Department of Energy

Enclosed is the report of the NRC-DOE meeting on the BWIP pre-ES geohydrology program, held in Richland, Washington during April 7-9, 1987. The report includes the summary of the meeting prepared by the participating groups at the end of the meeting along with copies of all other information presented at the meeting.

Enclosure: "Report of the Nuclear Regulatory Commission - Department of Energy Meeting of the Geohydrology Testing Program before Construction of the Exploratory Shaft," April 9, 1987, with 16 attachments.

# Cement Effects

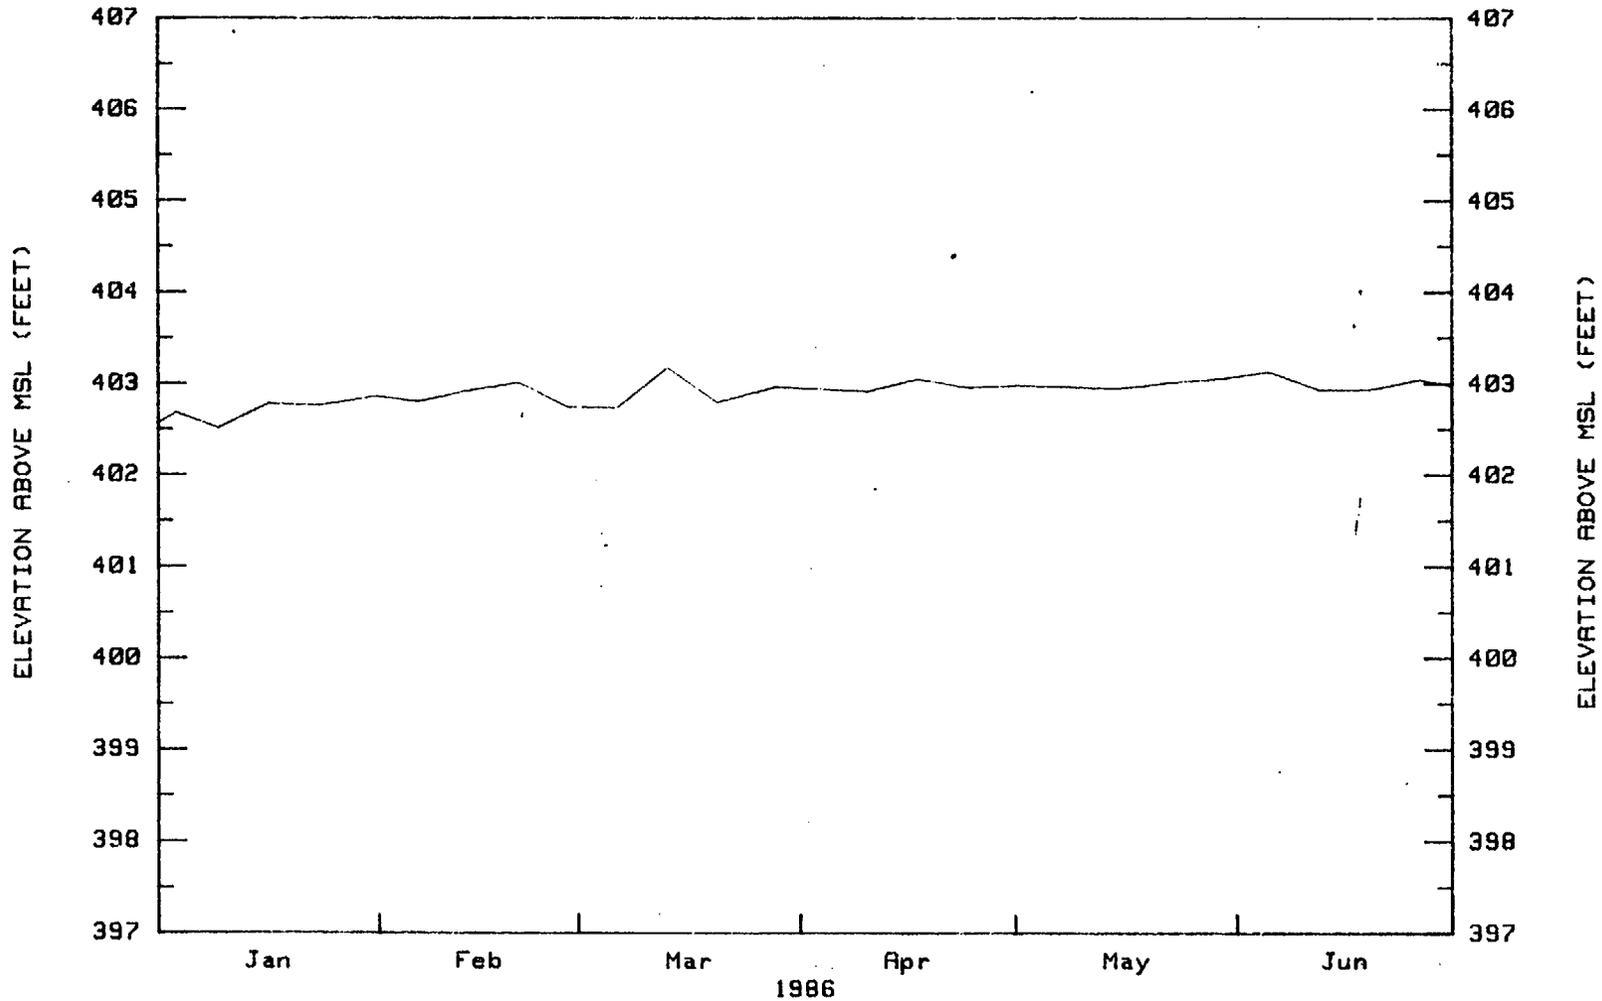
- **BWIP did not Document the Basis for Concluding that Cementing of the Rocky Coulee Flow Top at RRL-2A and RRL-6 During Construction does not Significantly Inhibit Hydraulic Communication**

- **BWIP has Provided the Requested Documentation**
- **Spot Cementing of Rocky Coulee Flow Top at RRL-2A had Minimal Effect on Hydraulic Properties**
  - **Transmissivity Estimates for Hydraulic Test Performed Pre- and Post-Cementing are of Similar Magnitude**
  - **Dynamic Temperature Logs Indicate Water Production from the Rocky Coulee Flow Top**
- **Cementing Effects on Hydraulic Properties of the Rocky Coulee Flow Top at RRL-6 not as Well Known**
  - **Time-Series Water-Level Data from Subsequent Monitoring are Consistent with Data from Other Rocky Coulee Flow Top Observation Points**
  - **Addition of Monitoring at DC-32 Makes Measurements at RRL-6 Less Critical**

# Pump Selection

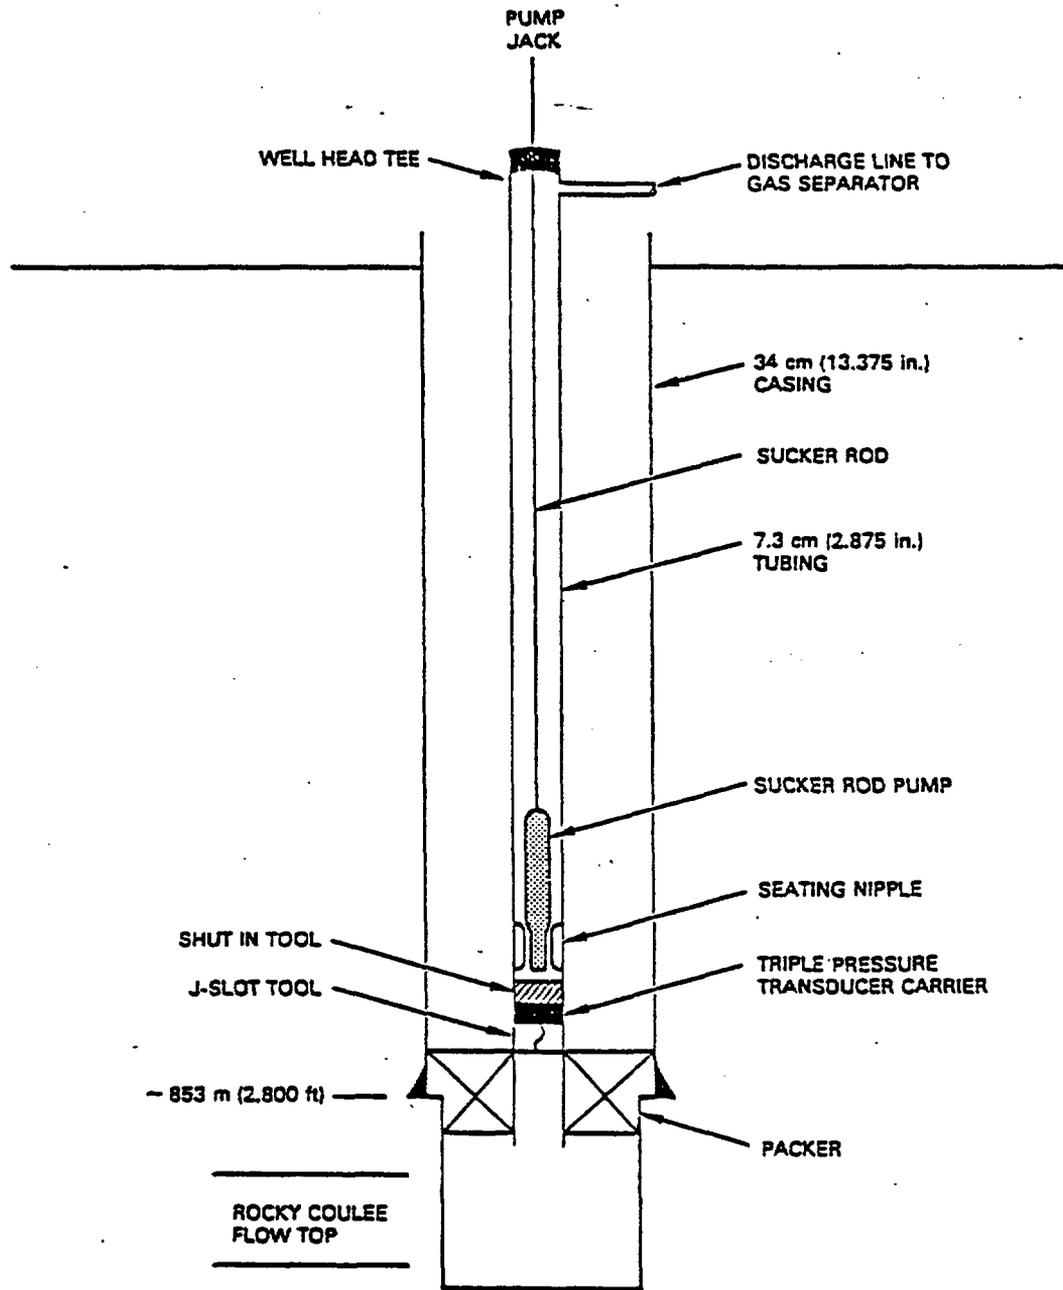
- **Pressure Fluctuations in the Pumping Well and Nearby Observation Wells RRL-2C and RRL-2A Complicate Test Interpretation**
- **Changes in Pumping Rate are Difficult to Accomplish**

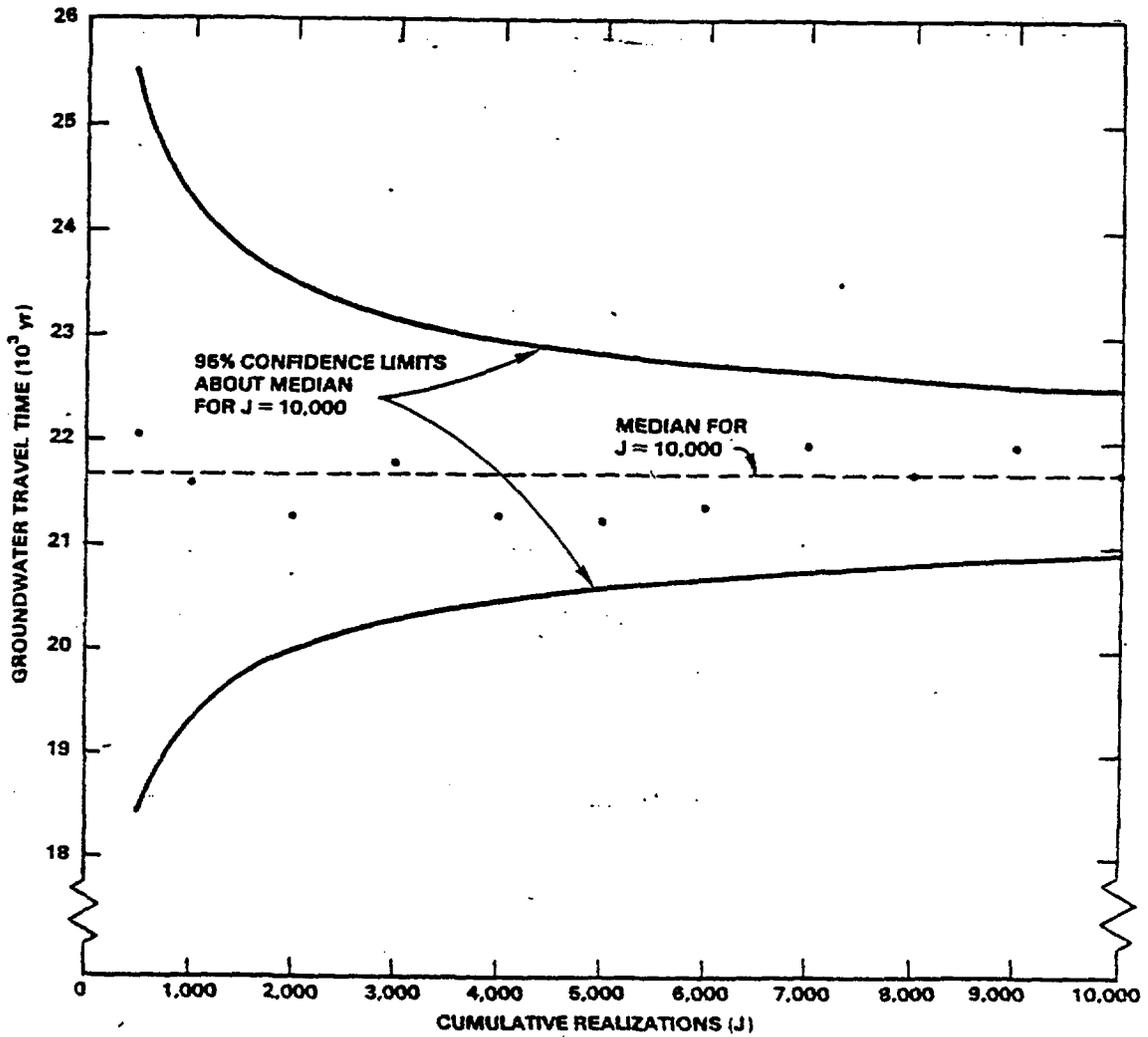
at the tail of the probability distribution. For example, it can be seen from Clifton (1984) (see Figure 2) that the median travel time does not stabilize even after 6,000 simulations. This problem would be more amplified in the tail of the GWTT distribution and a greater number of realizations would be needed to accurately assess the probability exceedance of 1,000 yrs. As a matter of fact, the number of Monte Carlo realizations utilized in order to depict the tail is probably small. As pointed out by Nguyen (1985), presentation of the GWTT probability distribution as a smoothed curve may be imprecise near the tail, which is the zone of interest. The investigators should provide an enlargement graph of the tail of the GWTT empirical distribution derived from the Monte Carlo analysis. A separate assessment of the interval of confidence, similar to that of Figure 2, should be provided for the tail region.

(ADAPTED FROM DOE, DEA, 1984)

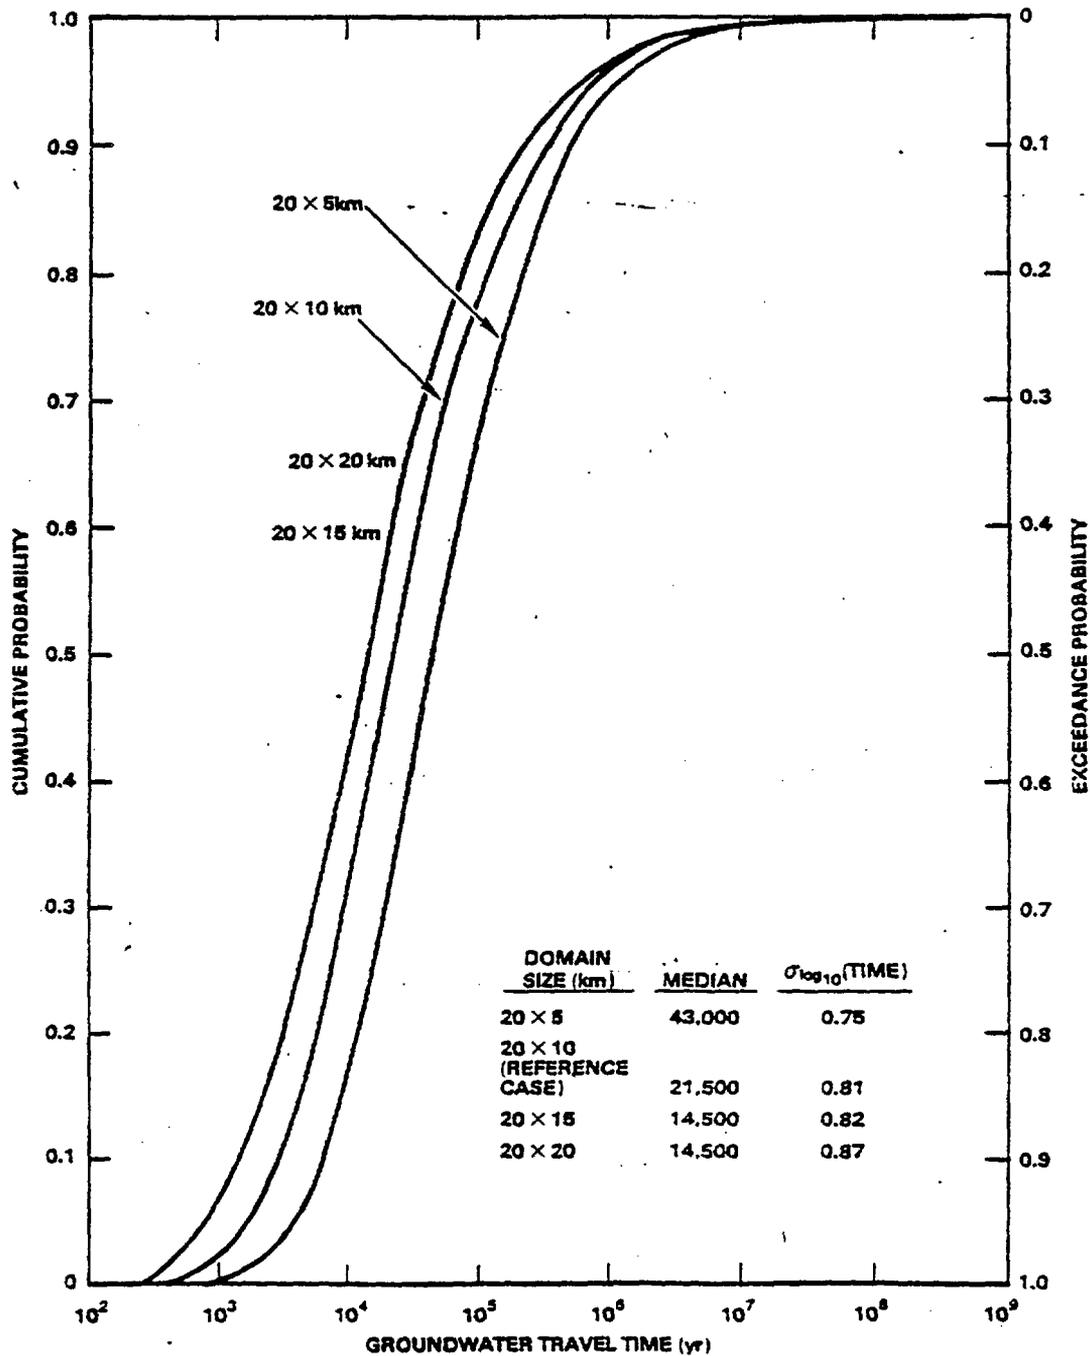
In their simulations, the authors have only taken into account the effect of vertical hydraulic gradient. The actual post-closure conditions encountered in the repository are far removed from the isothermal conditions implicitly assumed by Clifton and Arnett (1984). A proper analysis of the post-closure natural barrier performance should account for the coupled thermo-hydrological processes. This problem may be of importance since the accessible environment lies only 250 m above the repository at a downgradient distance of 2 km (DEA, DOE 1984) (see Figure 3).

FIGURE 1: LOCATION MAP FOR SELECTED BOREHOLES

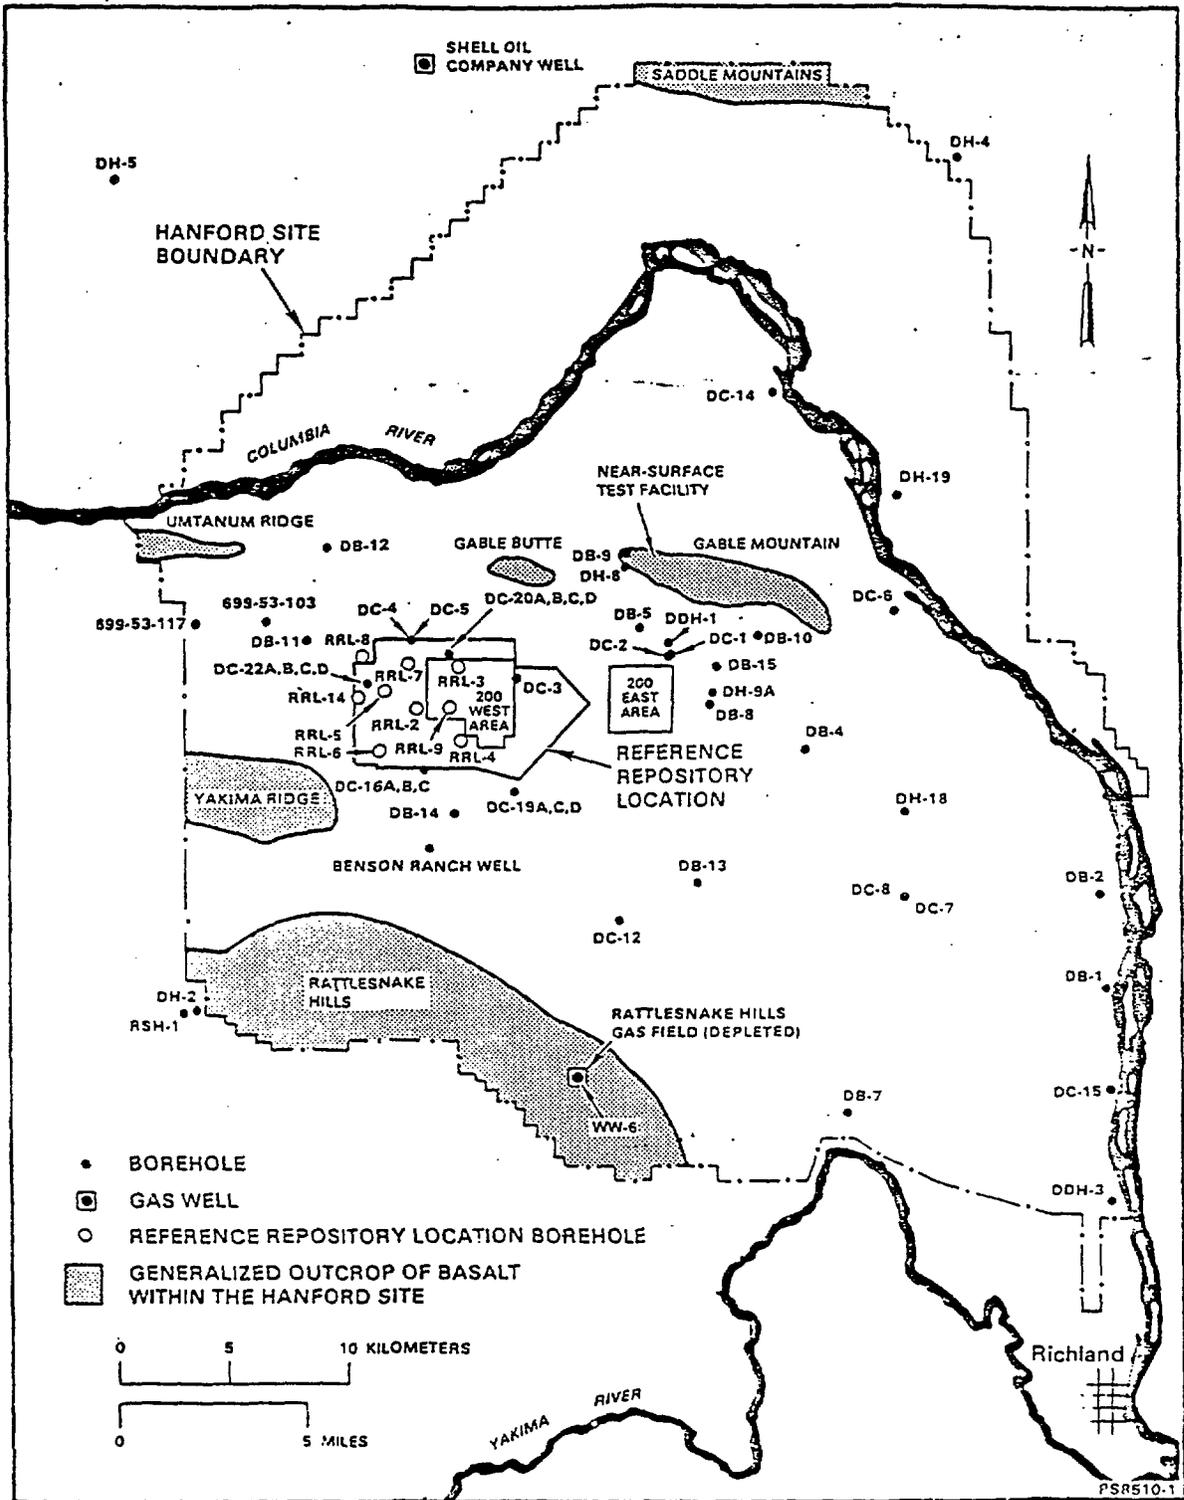
As shown on Figure 1, most of the boreholes screened in the Wanapum Formation are located in the vicinity of the RRL. Only DB-1, DB-2 and DDH-3 are located in the southeastern part of the Hanford Site. The effect of incorporating these three boreholes in the analysis on the estimated hydraulic head has been investigated. Structural models have been identified in two cases: (1) using observations from all eleven boreholes, and (2) not accounting for observations at boreholes DB-1, DB-2, and DDH-3.

FIGURE 2: LOCATION MAP FOR SELECTED BOREHOLES

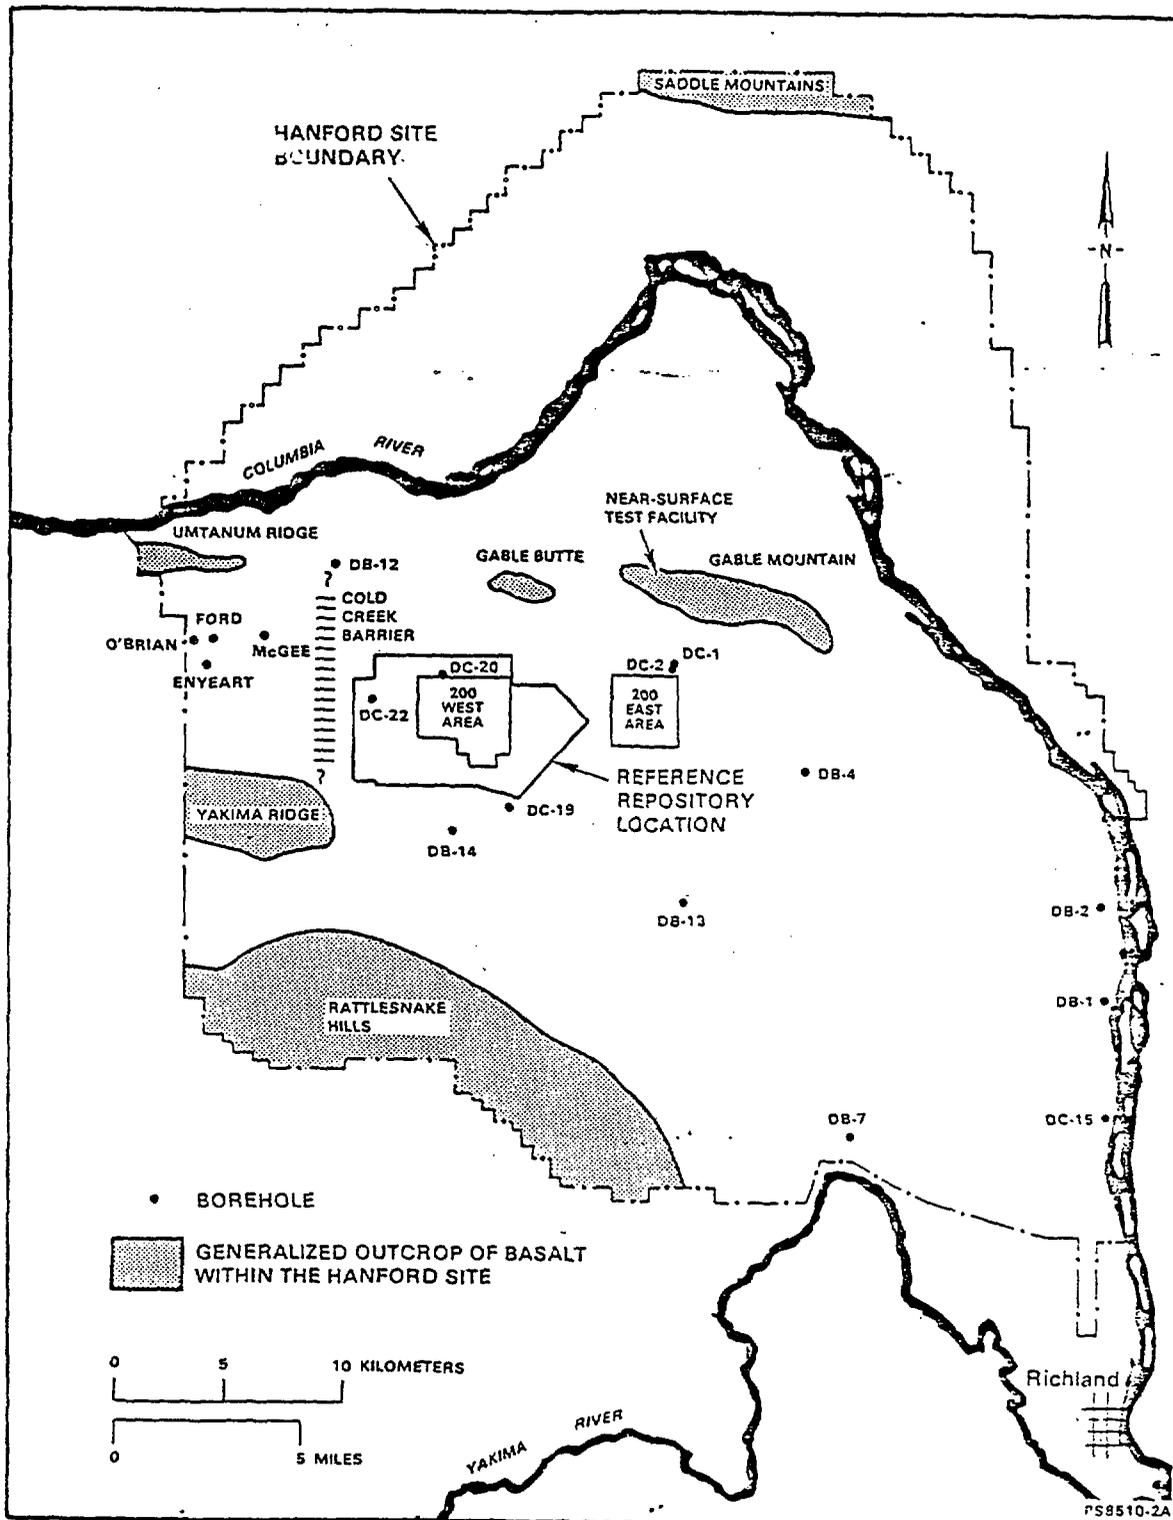
generally higher than the head elevations in the same stratigraphic horizon within the RRL east of the Cold Creek "Barrier" (Figure 2). This anomaly is interpreted by DOE as a no-flow or low-flow lateral boundary (DOE, 1986). However, this interpretation has not yet been substantiated by sufficient evidence. Since the water levels at the Ford and O'Brian wells behave differently than those at the other wells, and since such anomalies cannot be accounted for by a covariance function derived from a limited number of observations, these observations were dropped in the model identification procedure.
